Millstone Nuclear Power Station, Unit No. 3  
Response to Request for Additional Information  
Inservice Inspection Program  
Request for Relief from ASME Section XI

Millstone Nuclear Power Station, Unit No. 3  
Response to Request for Additional Information  
Inservice Inspection Program  
Request for Relief from ASME Section XI  
Revised Relief Requests IR-20 and IR-21

Relief Request: IR-20, Rev. 1

Relief Request: IR-21, Rev. 1

SUBJECT RELIEF REQUEST IR-20BY R.L. DATE 9-28-15

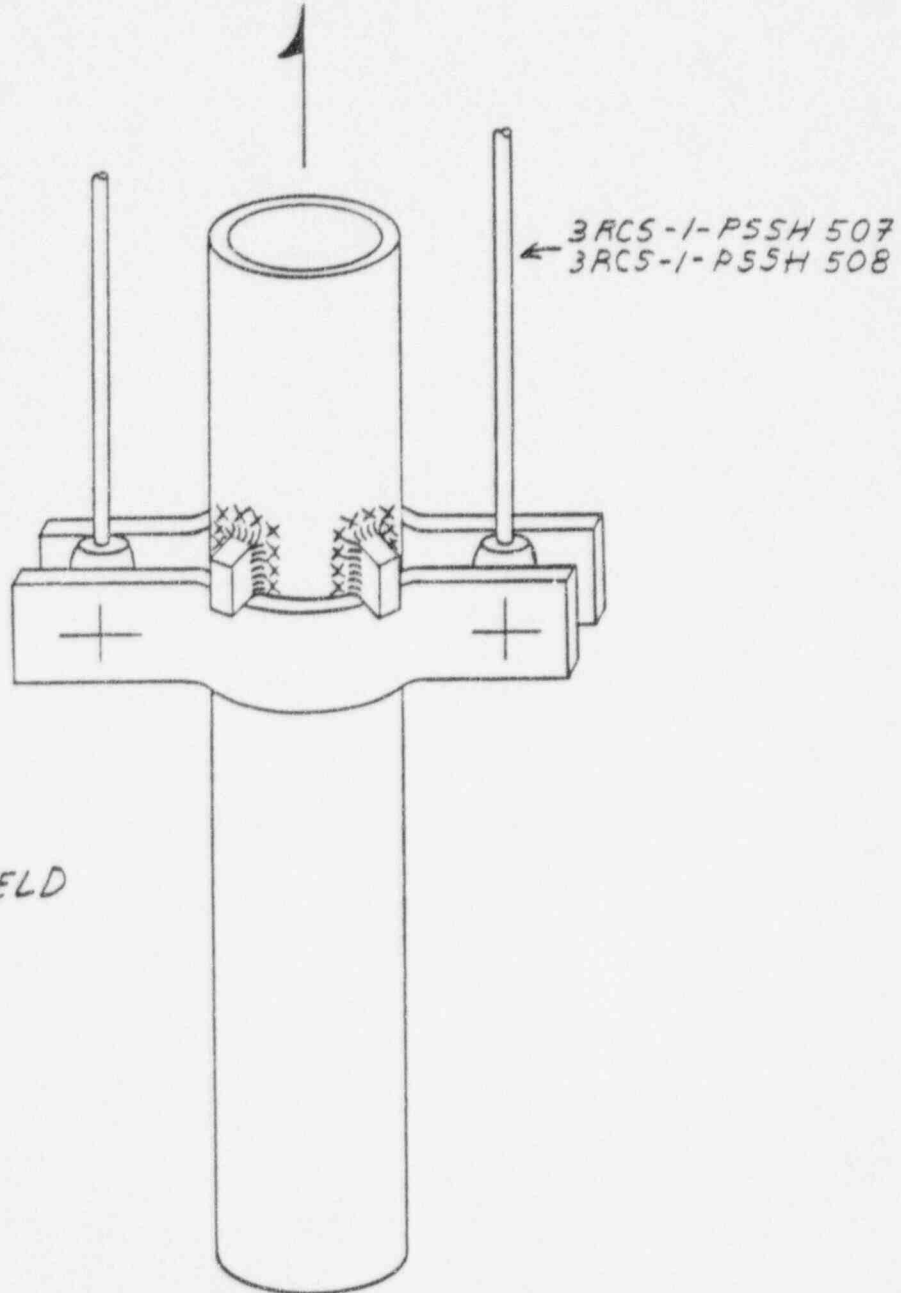
Access to these attachment welds is essentially limited to three sides, as shown on the attached diagram, due to a hanger clamp which prohibits one hundred percent surface examination coverage of the code required examination area. These welded support lugs are welded on three sides located on vertical pipe risers that transmit the load to variable spring can supports. Radiation levels were high, estimated dose rates were 200 - 400 mR/hour general area, 400 - 800 mR/hour on contact, with localized hot spots (crud traps and drain valves) of 10 R - 200 R/hour. In keeping with ALARA, regarding radiation exposure, to disassemble these spring can supports provides a very small increase in examination coverage with a disproportionate impact on personnel exposure. Relief is therefore requested from performing the inservice examination on the inaccessible portions of the exam area base metal located under the pipe clamp as noted in the attached table.

| Zone<br>DRWG/P&ID  | Exam Cat. &<br>Item No. | System | Component or Weld<br>Identification                                   | Size | Exam | Data Sheet | Configuration/<br>Limitation                                   |
|--------------------|-------------------------|--------|---|------|------|------------|--|
| 030<br>25212-20932 | B-K-1<br>B10.10         | RCS    | RCS-504B-PSSH507<br>Integral attachment to<br>pipe for 3RHS-1-PSSH507 | 8.00 | LP   | 93-PT-053  | Side under clamp<br>not accessible;<br>83% of weld<br>examined |
| 030<br>25212-20932 | B-K-1<br>B10.10         | RCS    | RCS-504B-PSSH508<br>Integral attachment to<br>pipe for 3RHS-1-PSSH508 | 8.00 | LP   | 93-PT-065  | Side under clamp<br>not accessible;<br>83% of weld<br>examined |

Surface examinations on the accessible 83 percent of the required examination area as required by ASME Section XI, IWB-2500 were performed during the fourth refueling outage. In addition, inservice system leakage tests were performed in accordance with Category B-P, IWB-2500-1.
